CITY OF NEW BRAUNFELS, TEXAS
LAST TUBER'S EXIT IMPROVEMENTS – UNDERWATER LANDING

ADDENDUM NO. 2

August 1, 2024

00 91 01 ADDENDUM NUMBER 2

GRAB BAR FLANGE DETAIL AND ANCHORAGE DETAIL

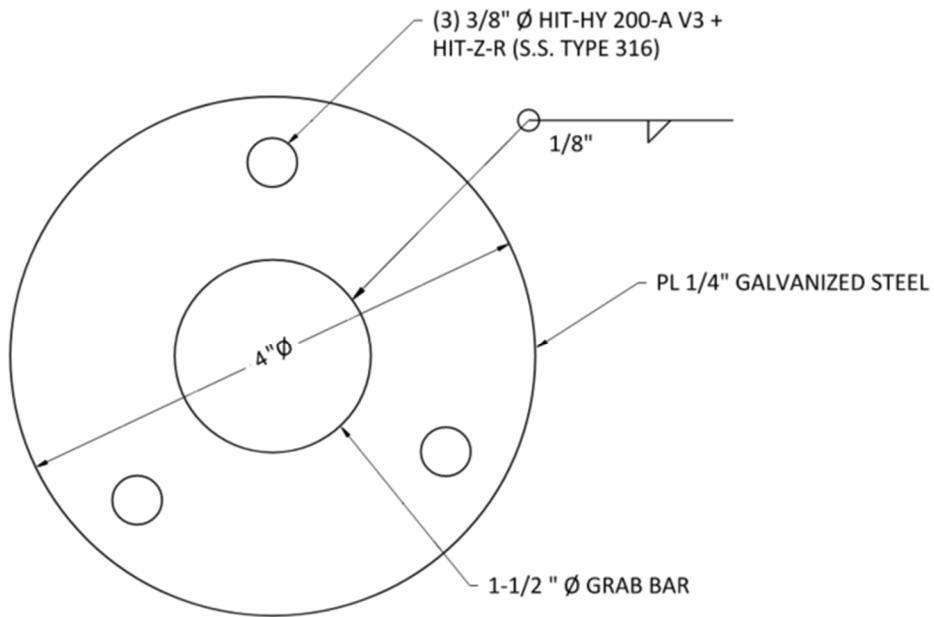
A2-1 SHEET C-8, HANDRAIL DETAILS, SEQ. 12 OF 14

Reference: DETAIL 6, GRAB BAR FLANGE DETAIL AND ANCHORAGE DETAIL

Modification: Replace the detail shown in DETAIL 6 with the following detail:

1. INSTALL (3) $\frac{3}{8}$ " ϕ HIT-HY-200-A VC + HIT-Z-R (S.S. TYPE 316)
OR APPROVED EQUAL
2. GRAB BAR MUST COMPLY WITH 2010 ADA STANDARDS FOR
ACCESSIBLE DESIGN SECTION 1009.5
3. CONTRACTOR TO ROTATE ANCHORAGE ORIENTATION TO
AVOID INTERFERENCE AT STAIR CORNERS
